Document Number : IB-24-13

Title : Change in Connector and Loadcell Housing of InBody120 IF Board

1. We are much appreciated for the hard work from branches and subsidiaries.
2. Change Classification (Reason)
 - To ensure compatibility of spare parts, Loadcell Housing and Board Connector have been modified.
3. Changed Details
 - 3.1 Modification in IF Board Connector

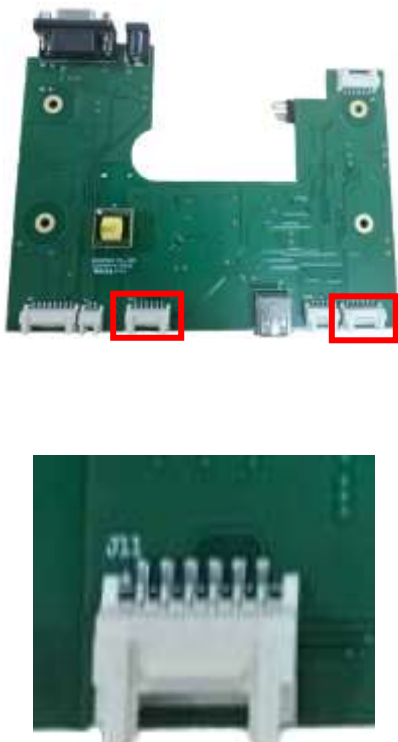
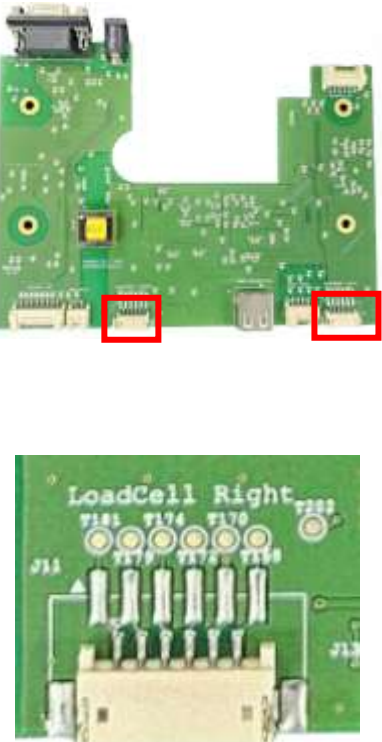
Item	Before	After
Photo		
Connector	20037WR-06	15001WR-06
Board Rev	D	E
Item Code	I8F310001	I8F310002
Item Name	Board IF 120	Board IF 120 (CE 4th)

3.2 Modification in Loadcell Housing

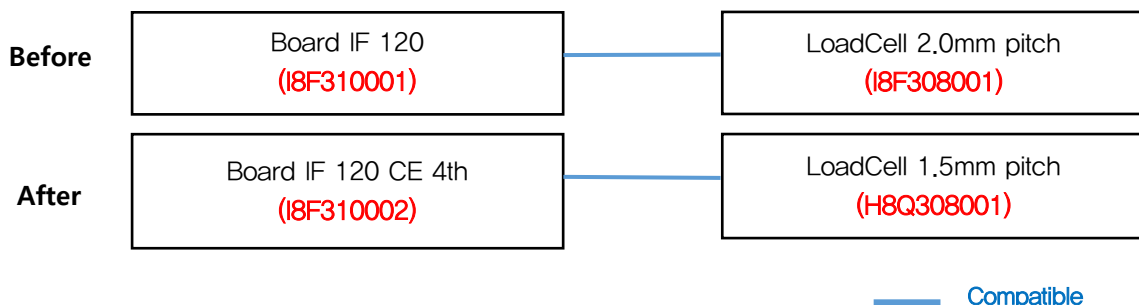
Item	Before	After
Photo		
Housing	SMH200-06 (2mm pitch)	15001HS-06 (1.5mm pitch)
Item Name	[CS][Assy]LoadCell 2.0mm 120/H20B	[Assy]Loadcell 1.5mm 120/H20B/H30/H40/Fit
Item Code	I8F308001	H8Q308001

- Since the modified parts are not compatible with existing components, IF Board and Loadcell must be replaced as a set.
- The older model Board IF 120 and LoadCell 2.0mm can still be ordered.
